RS has been building the RS700 since 2001. Not much has changed to the build spec over the years, some strengthening here and there but nothing major. The hull and deck tooling has certainly stayed the same. 16 years later and over 350 boats built the tooling's were showing their age. Before the next batch of boats were built I thought it was a perfect opportunity to invest some time and effort to refresh the boat and to show our support to the class. We hope that current owners will be excited by the result and that current sailors and new to class will be encouraged to buy new boats. It's worked as we have now sold the first batch of boats built this year and now half way through the second batch due to be built in the autumn.

The changes are essentially about improving the quality, attention to detail and enhancing the pleasure of ownership. Having said that, some of the changes address some of the annoying structural and water ingress issues that crop up every now and then, not major, just really annoying to the customer.

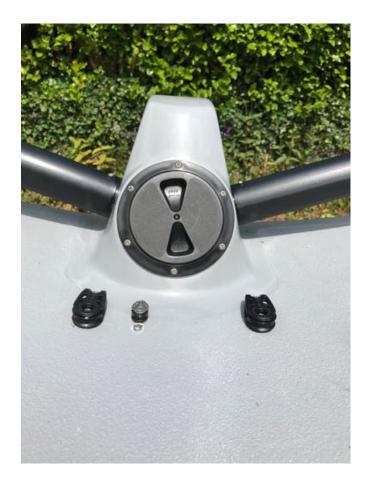
A simple straight dagger board case (set at the same angle as the current board, if it were held to the back of the case with shock cord) would be a much better solution. And give far better support for the board. I have replicated the Aero arrangement. The Aero has a fully lined (at top and bottom) straight case. The trailing edge of the board is supported along the entire length of the case by a plastic strip and the board can be lowered and raised easily to depower and lift out in a hurry. Overall it looks and feels much cleaner and operates more efficiently.

A final consideration is that the current board is very expensive and at can take time to get stock. Other than for new boats, RS will not sell many (or any) spare RS700 boards so there may be times when we won't have any in stock. I would like the option of using the RS Aero dagger board for the RS700 and it may become a necessity at some point in the future. It makes financial and stock management sense for all to migrate to the Aero board sooner rather than later. This would have to go to a vote and perhaps a trial can be initiated with feedback before moving forward on this.

It would be an option to use either the Aero board or the current board in the new straight case. Some repacking of the case may be necessary depending on which board the sailor chooses to use.
